DESIGN #	DRAWN BY UP	DART AEROSPACE LTD HAWKESBURY, ONTARIO, CANADA	
CHECKED #	APPROVED #	DRAWING NO. DSI 9242	REV. A SHEET 1 OF 1
DATE 02.11.01		TITLE SPACEDOOR MODIFICATIONS	SCALE NTS
A	02.11.01	NEW ISSUE

DART SERVICE INSTRUCTION

TO AMEND B04-73001 REV. B
B30-23000 REV. F
IIN-D412-694 REV. A
REF. FAA STC: SH8625SW

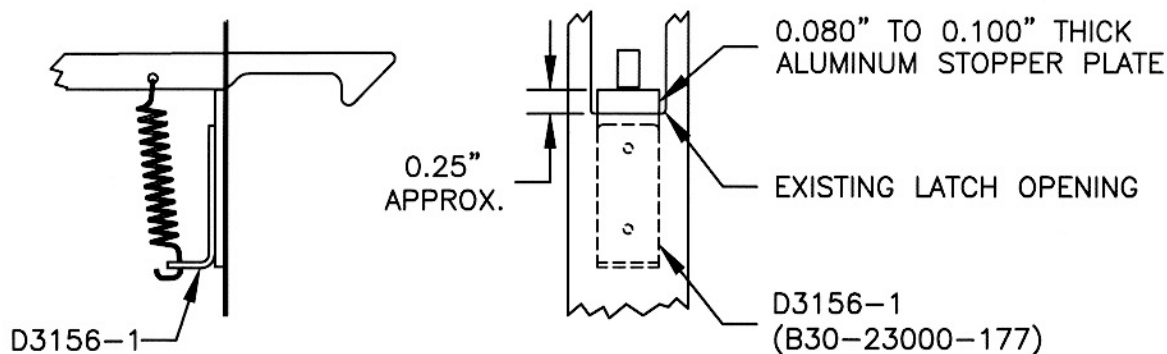
- 1) REPLACE D3109-041/-042 (REF. PREMIER P/N B30-23000-109/-110) WITH BHT P/N 412-030-304-105/-106 MODIFIED AS FOLLOWS.
